ADDENDUM NUMBER 03

DATE: January 31, 2024

PROJECT: Cass District Library Edwardsburg, MI

PROJECT NUMBER: 22-1836

1 ENLARGED FLOOR PLAN - LIBRARY BOOKCASE
A6.0 3/8" = 1'-0"

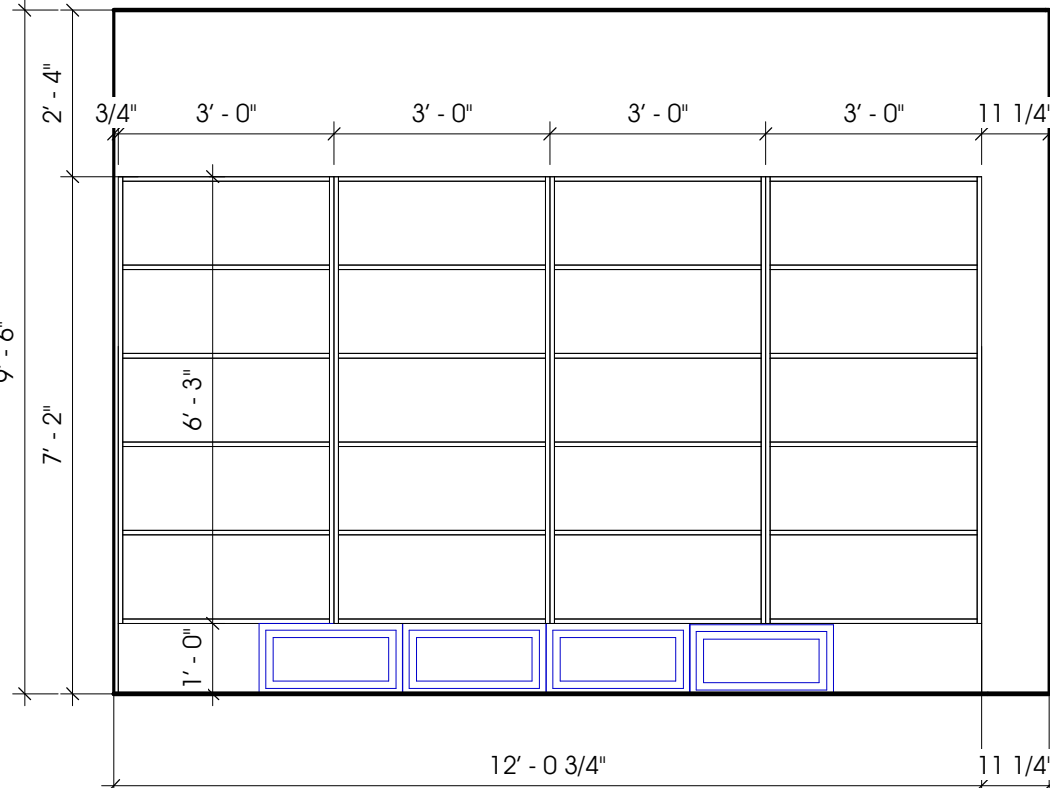
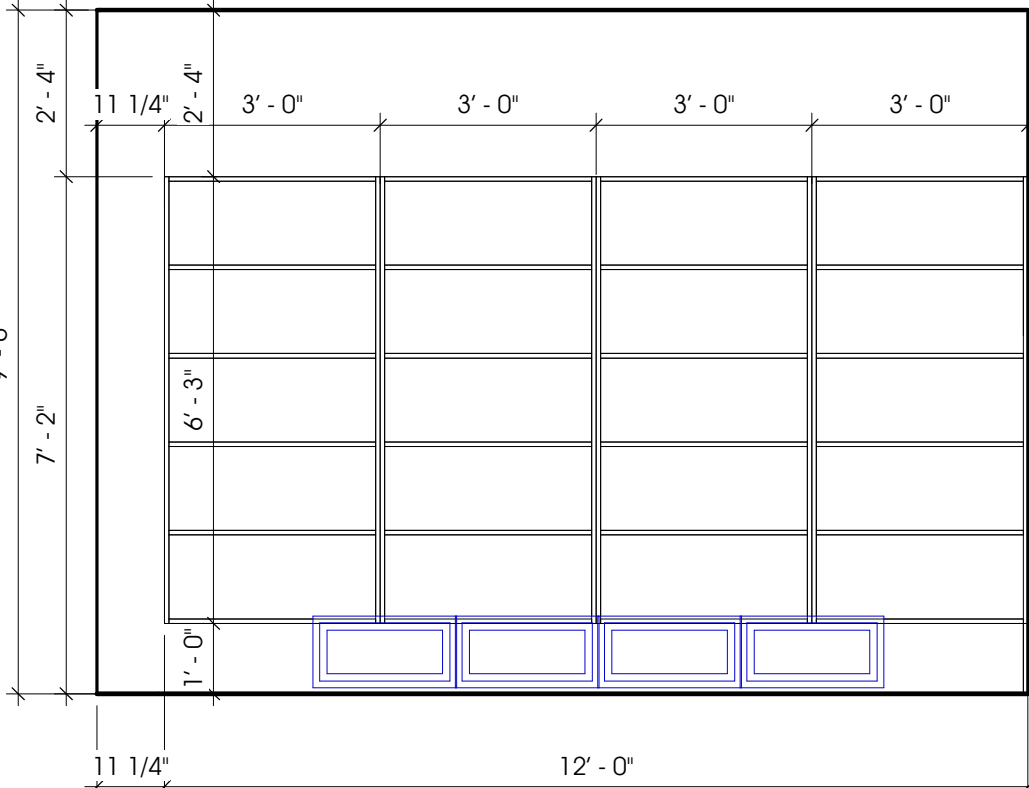
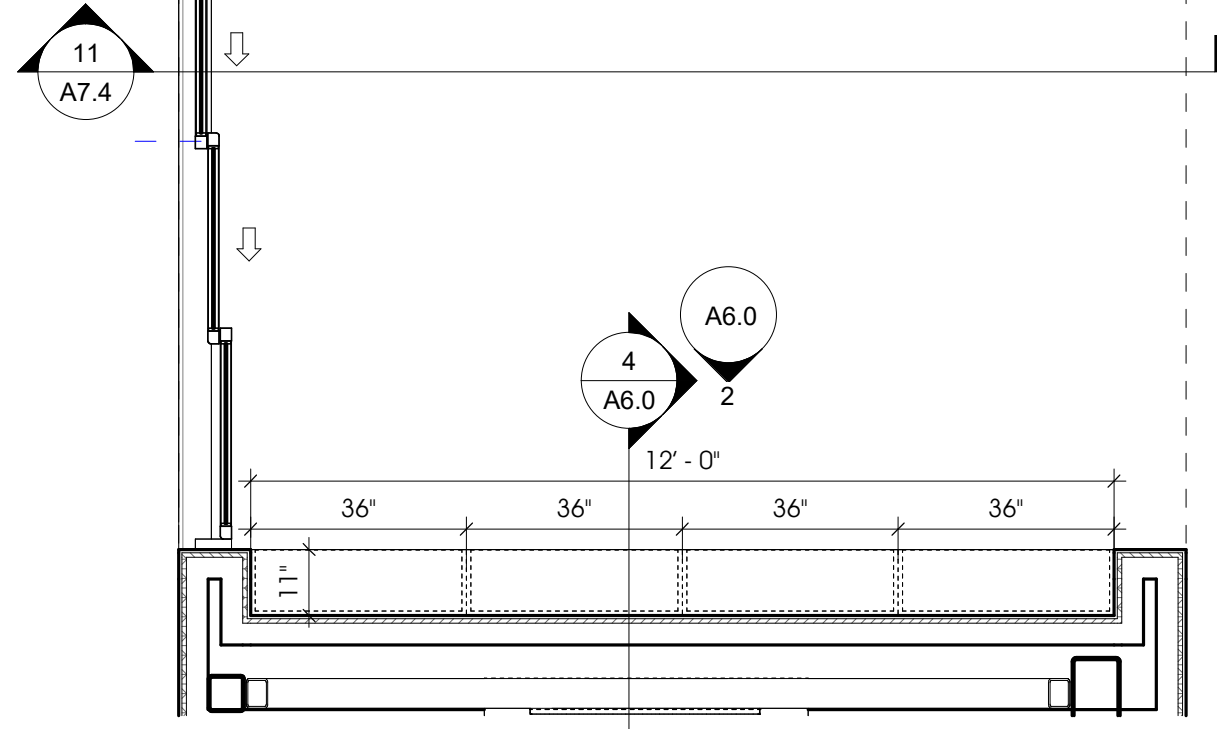
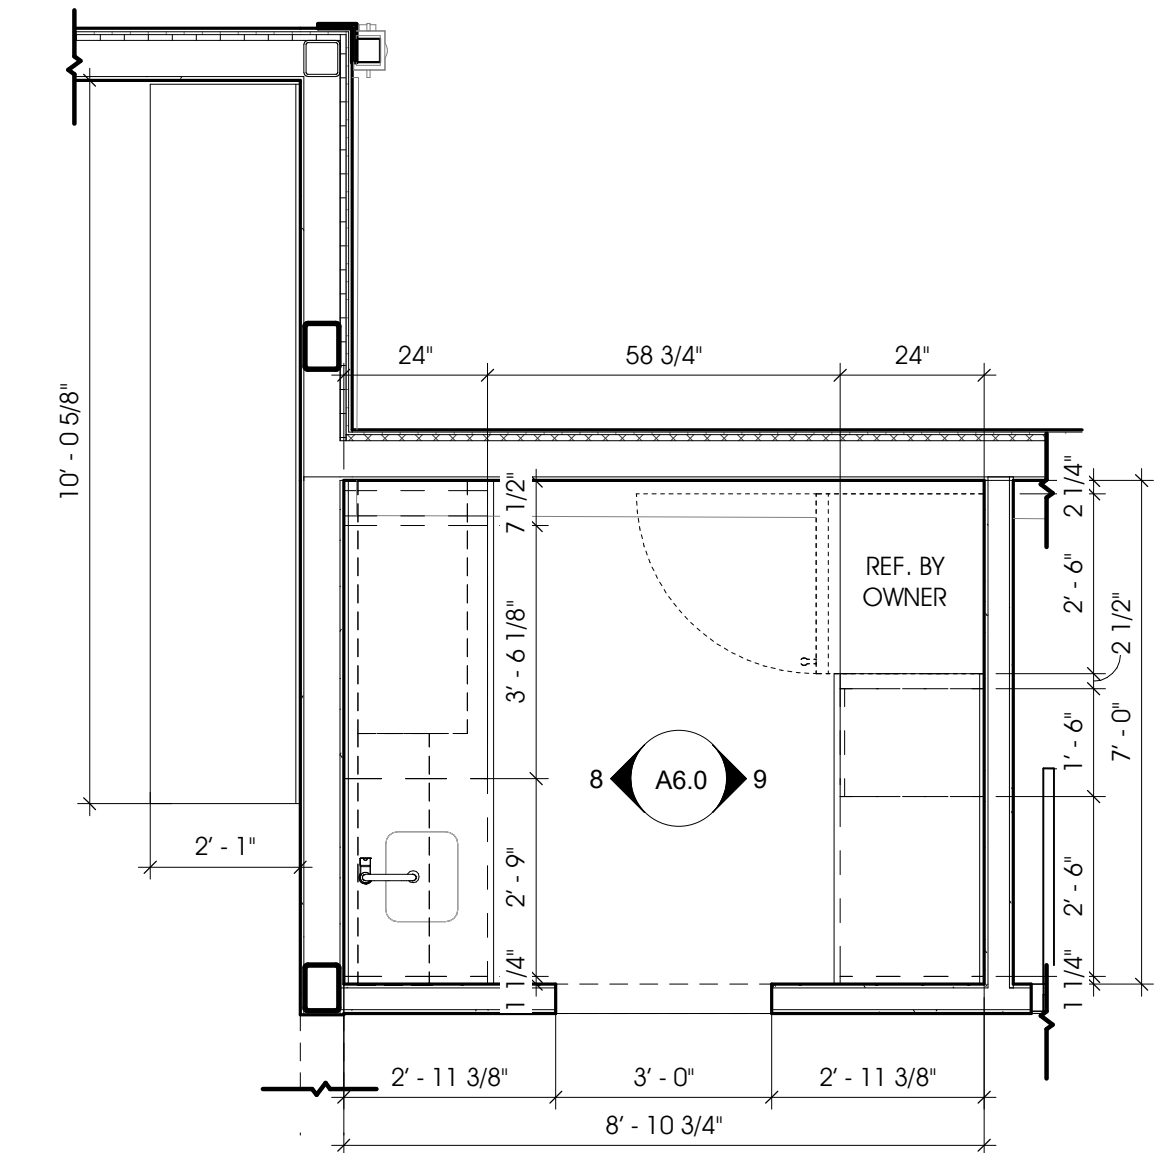
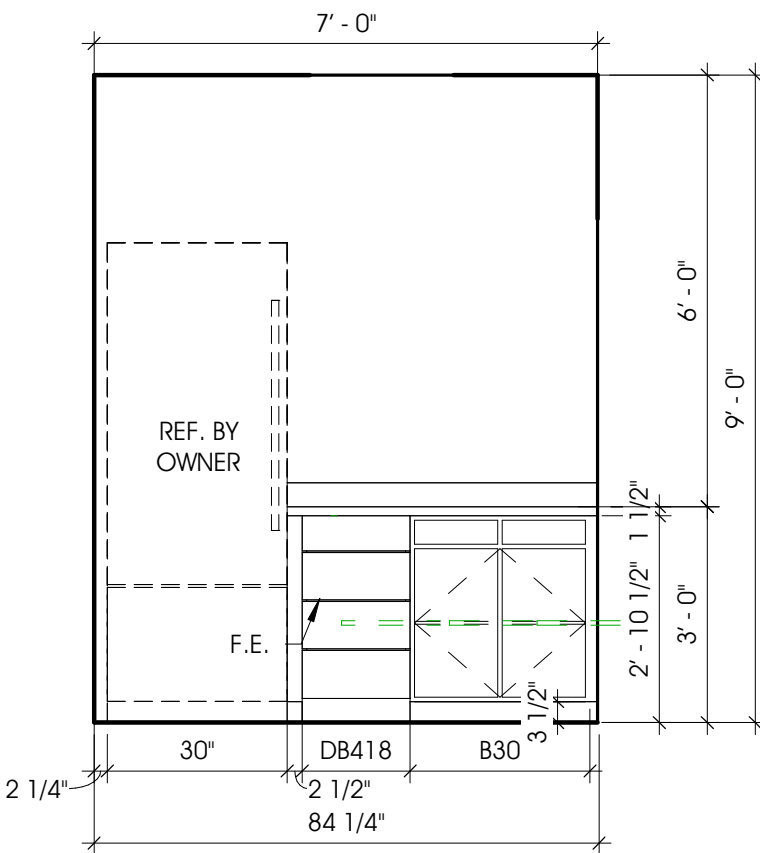
15. **REVISE** Library bookshelves to show mechanical venting grills and clarify keynoting.

42. Who is responsible for elevation 10/A6.0? Please clarify.
- a. Cabinetry in multi-purpose room to be provided by owner.
43. Who is responsible for the bookcase shown on 2,3/A6.0? The section view 4/A6.0 does not offer much clarification.

- a. GC shall be responsible for bookcases on 2,3/A6.0. Please see revised details **1,2 & 3/A6.0**.
44. What are the intended finish edges of the laminate panels? How do they terminate into ceilings, outside corners, inside corners, door frame?

1 FURNITURE PLAN
A9.1 1/8" = 1'-0"

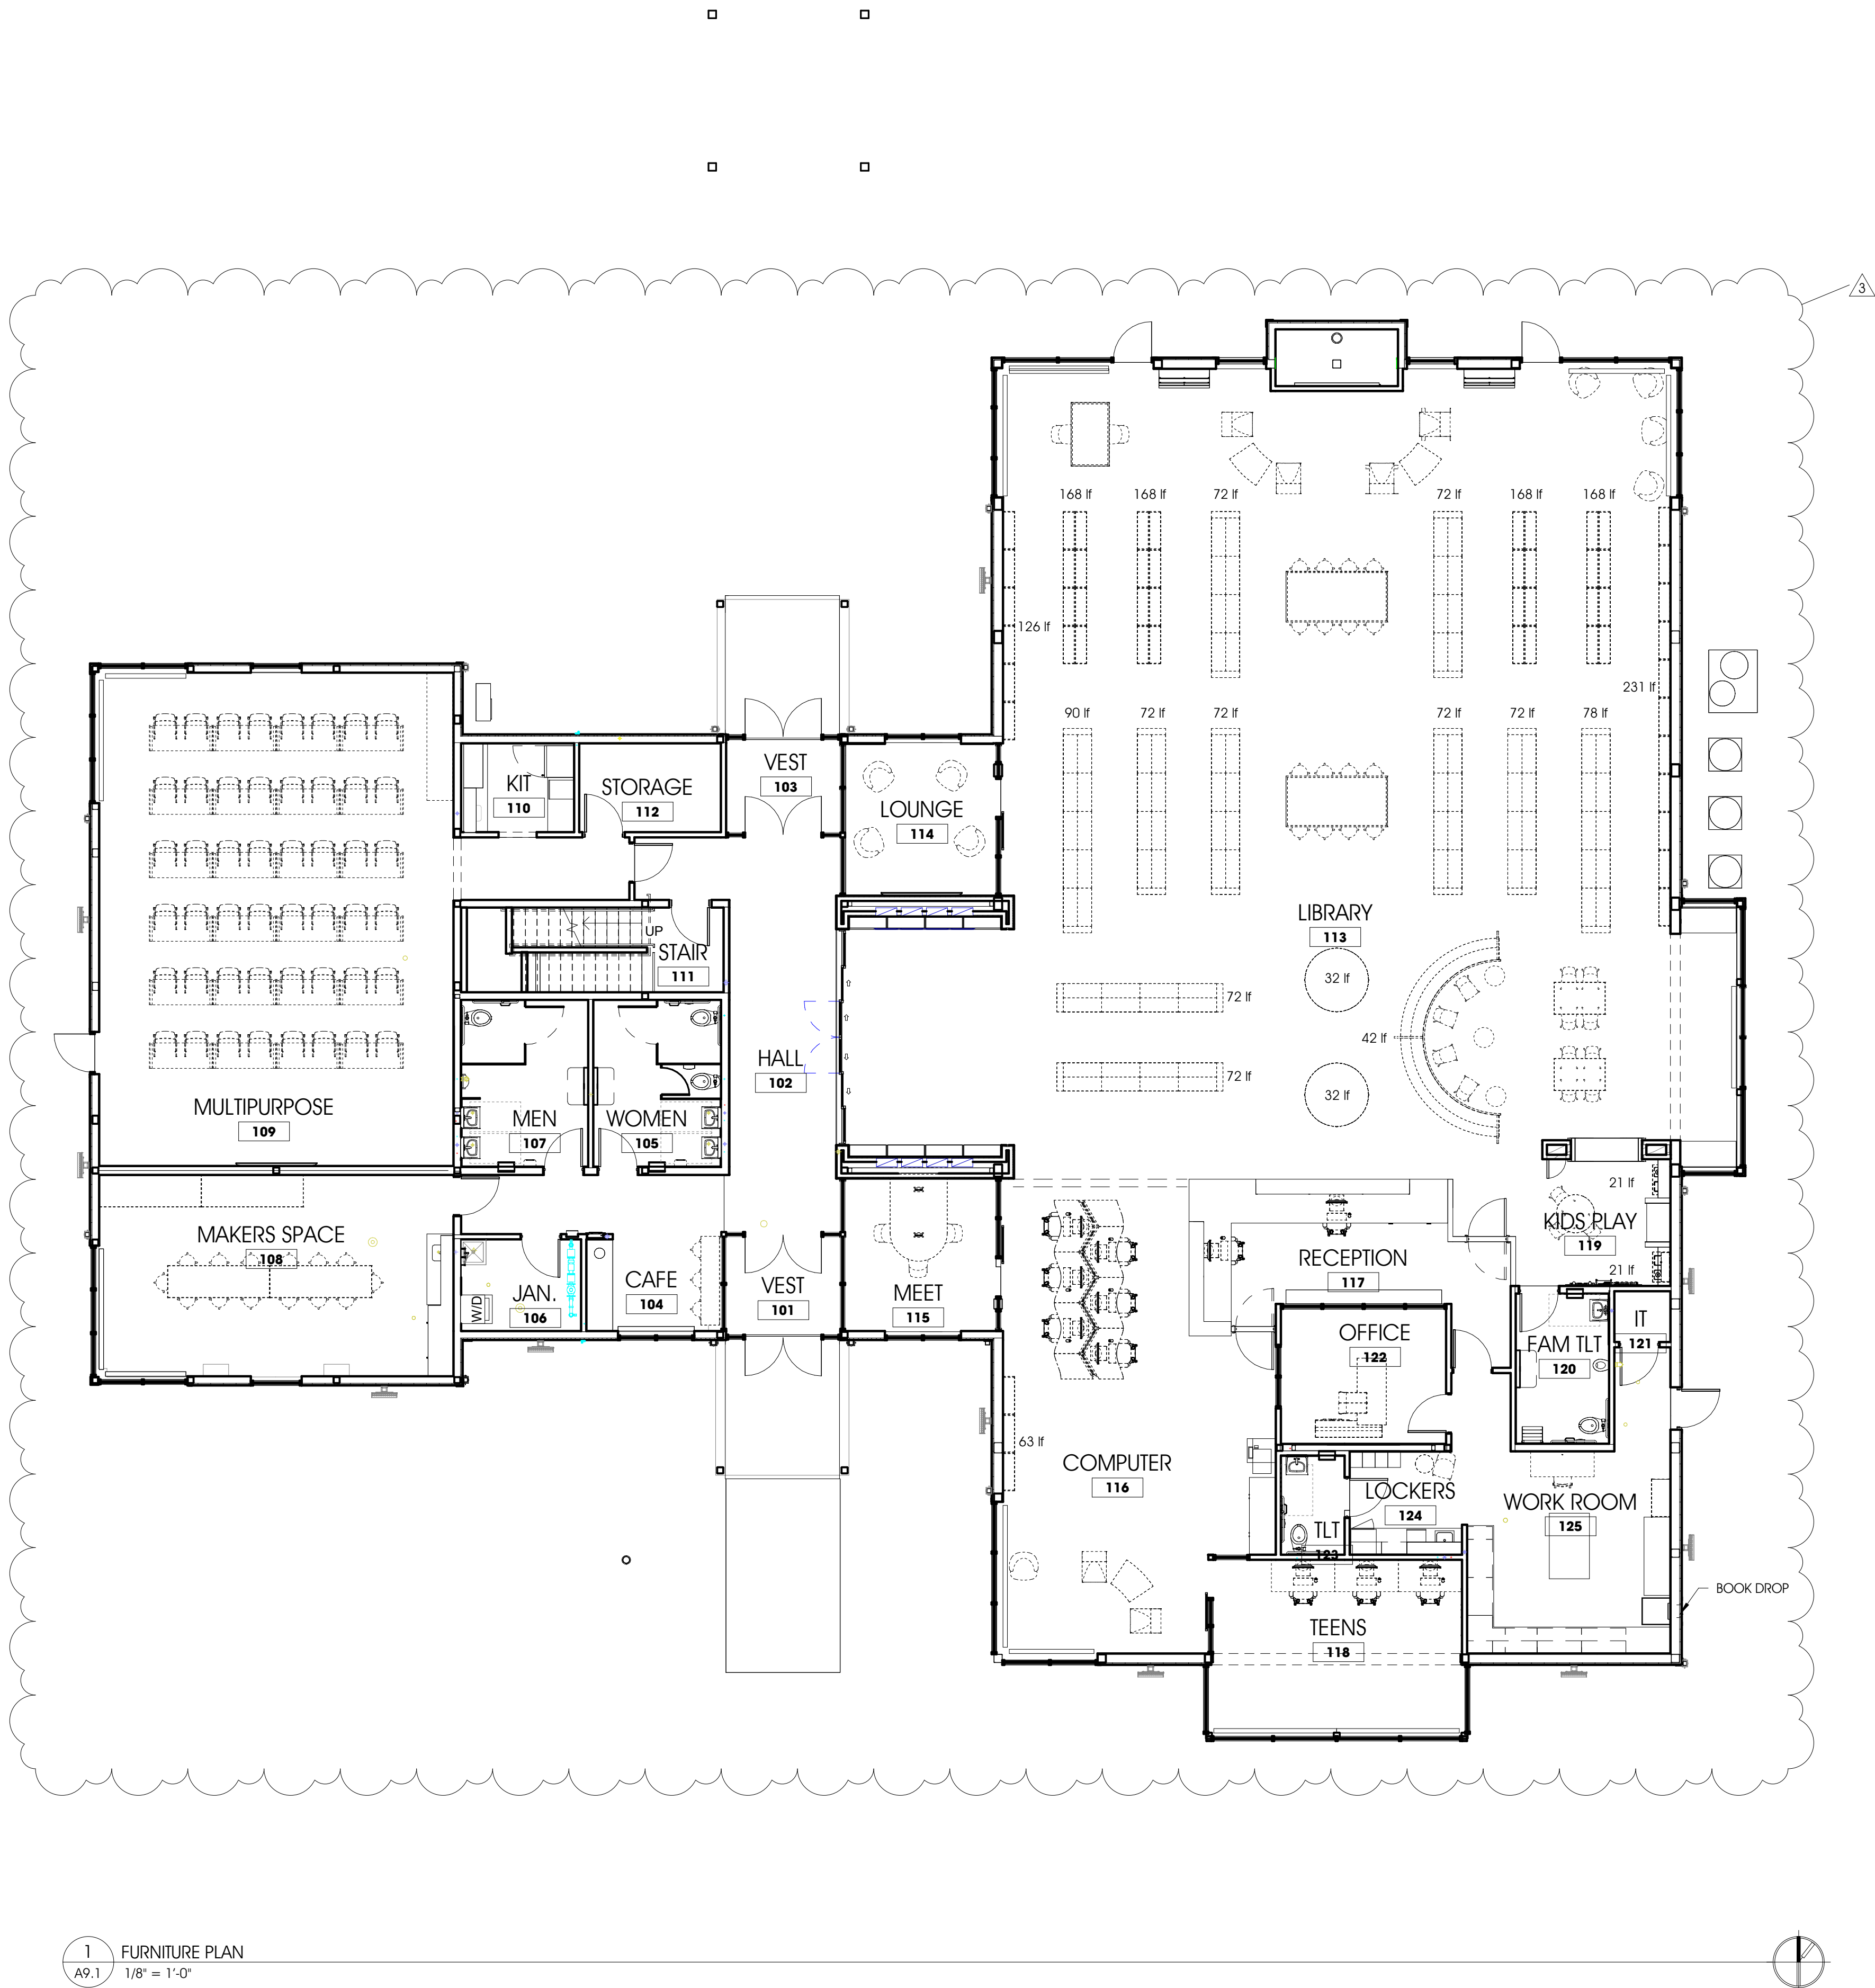
19. **REVISE** Line weights and types to show owner provided items.
